**STAGE 2  
WORKPLANS**

**RE: Stage 1 Final Investigation Report and Amended Stage 2 Abatement Plan  
EME Jct. D-1 Site (AP-67)  
T20S-R36E-Section 1, Unit Letter D  
Lea County, New Mexico**

**STAGE 1 FINAL INVESTIGATION REPORT AND  
AMENDED STAGE 2 ABATEMENT PLAN**

**EME JCT. D-1 SITE (AP-67)**

FIGURE 6  
 PROPOSED OUTLINE OF  
 RE-SEEDING AREA AND  
 INFILTRATION BARRIER

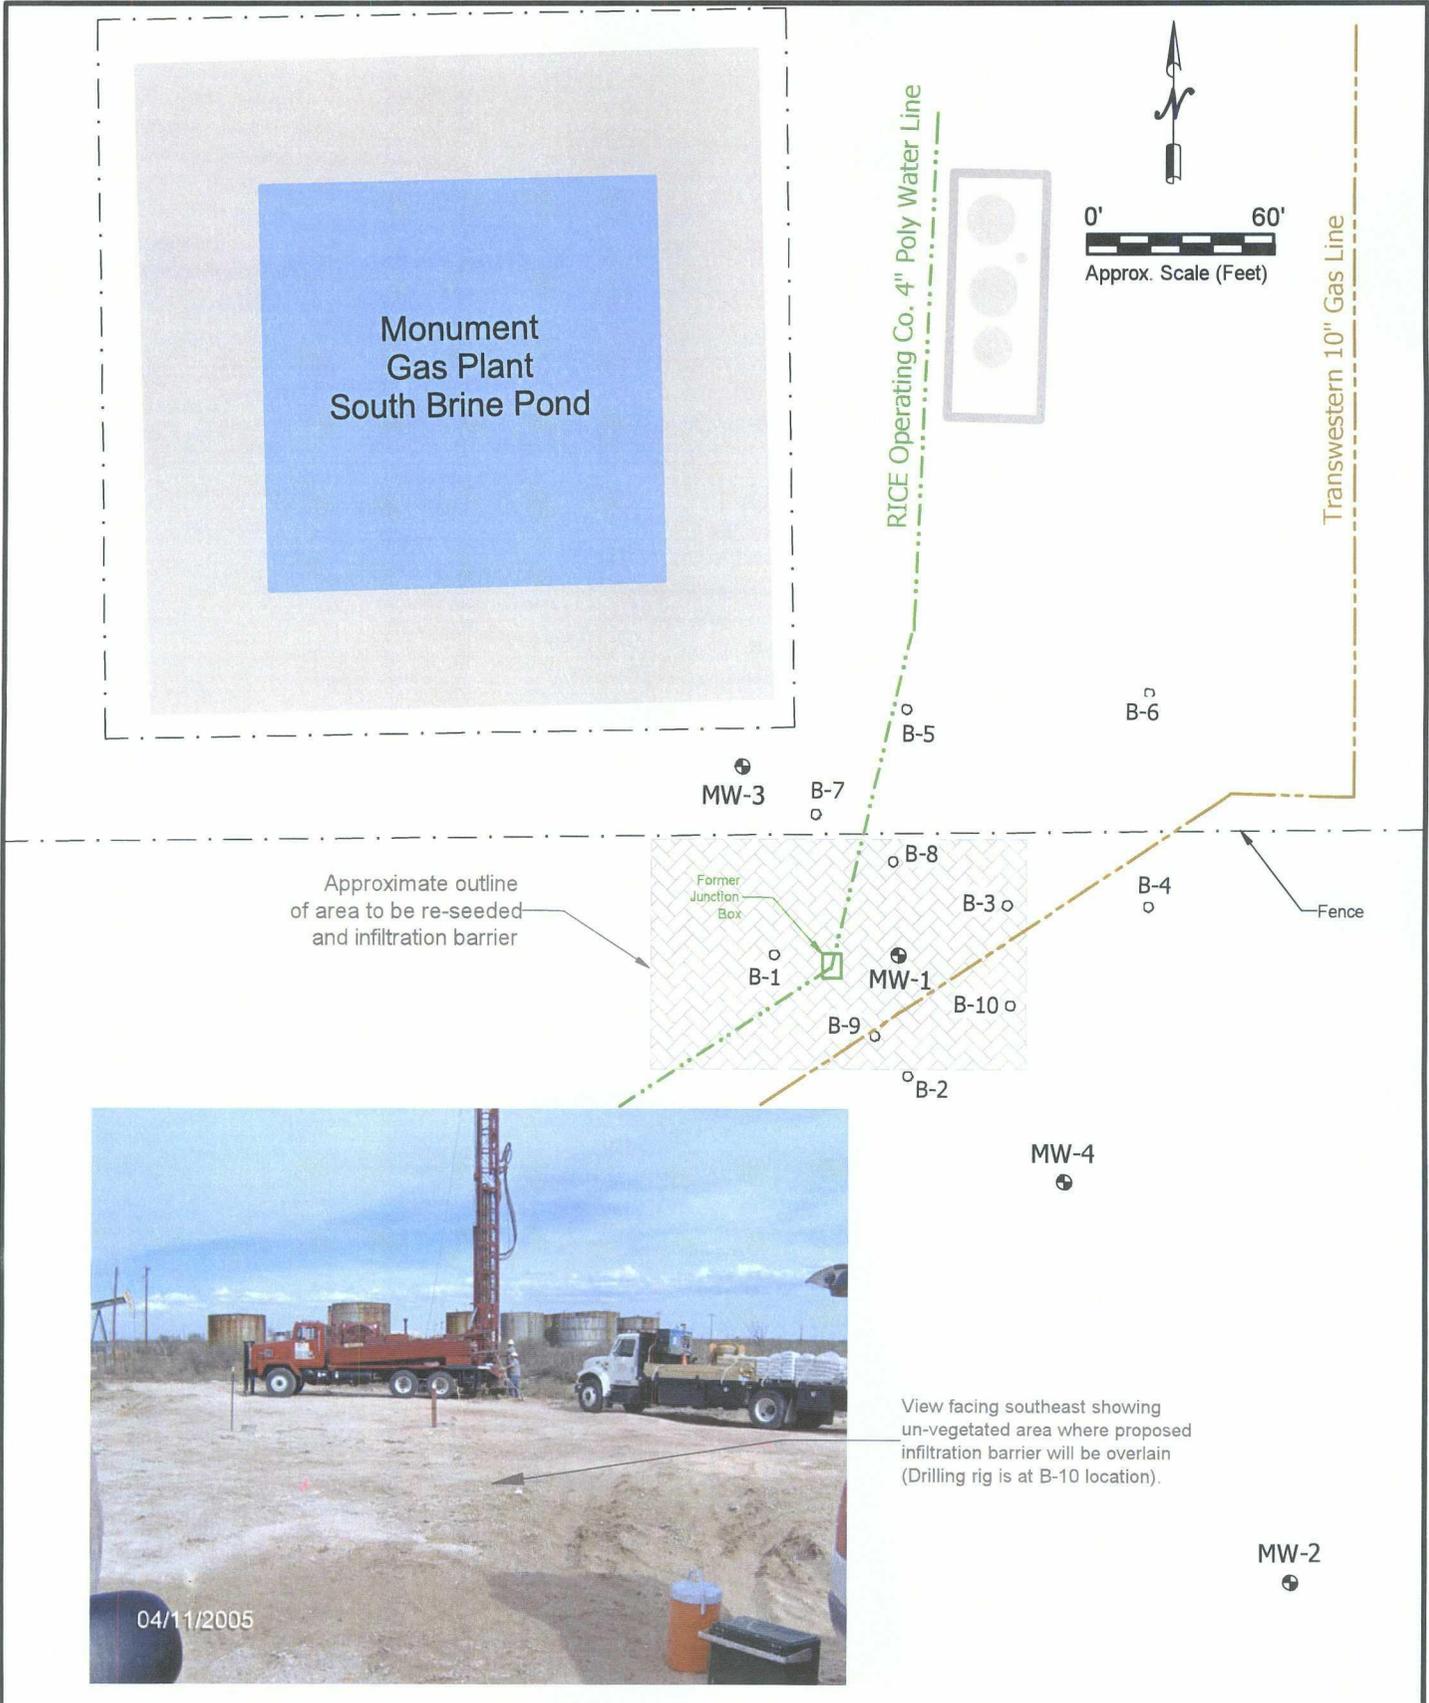
1. The Corrective Action to the Vadose Zone must include that at least 4 feet of clean soil will be used for the cover material, including selected topsoil to encourage native plant growth.

ROC further proposes the creation of an infiltration barrier using imported clean sandy loam for the topsoil layer and re-vegetating the surface which will enhance the effectiveness of the existing clay layer. An approximate 8,800 ft<sup>2</sup> area in the vicinity of the former junction box where there is a lack of vegetation will be re-seeded with a mixture of native grasses and plants that will re-vegetate the area at a natural rate. The infiltration barrier will enhance the effectiveness of the clay layer by providing two natural processes to control infiltration: (1) soil provides a water reservoir, and (2) natural evaporation from the soil plus plant transpiration empties the soil water reservoir. The infiltration barrier will consist of a layer of soil (sandy loam) that will support the growth of native grasses and plants and will vary in thickness to match the surrounding terrain of the dune sand habitat. The cover will contain at least 4 feet of clean soil with a concentration of less than 500 mg/kg chloride to encourage native plant growth.

Figure 6 depicts the area proposed for re-seeding and construction of the infiltration barrier. ROC will monitor the site for continued healthy growth of vegetation and add amendments if necessary.
